Winnebago Industries, Inc. submits the following report pursuant to Part 573 of the NHTSA regulations. The numbered paragraphs below correspond to those found at Part 573.5(c).

SUBJECT: Campaign #92 – Am-Safe Seat Belt Buckle

INSTRUCTIONS TO PERFORM CAMPAIGN #92

Replacement of Seat Belt Buckle Assembly on a Limited Number of Class A Motorhomes and Rialta Motorhomes

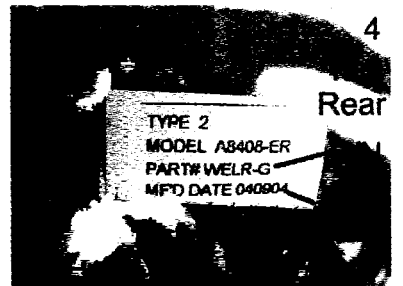
- Look for the product tag label near the anchor bolt bracket of the tongue-end belt assembly as shown in photos 3 and 4.
- If the belt also includes an extension (shown in photo 5) inspect the part number and manufactured date of the extension as well.
- Inspect the **part number** of the belt assembly (NOT the model number). **The buckle assembly must be replaced if the tag contains a part number and date code shown in the chart below.** Defective buckles will have one of the part numbers shown and date codes in MMDDYY (2-digit month, date, year) sequence.

This photo shows the 'back' of the tag, which includes the pertinent information, including model no., part no., and date of manufacture.

Assembly Type	Am-Safe Part No.	Replace belts within range of Mf'd Date:	Order Wbgo Part No.
three-point	WELR-G	9-5-03 to 3-22-04	091990-04-792
three-point	I-4024	9-8-03 to 3-22-04	091990-04-792
three-point	I-1208	12-12-03	118350-04-792
lap belt	ODELR-R	9-8-03 to 3-22-04	118350-04-792
lap belt	90ER	9-8-03 to 3-22-04	114258-04-792
extension	I-1331	1-5-04	091990-01-792

- **NOTE:** If the part number is not shown on the chart, no replacement is required. If the recall has already been performed, there will be a tag near the buckle on the replaced belt. If a front seat 3-point belt buckle has been replaced, there will be a hole punched into the plastic belt sheath mounted to the side of the seat.
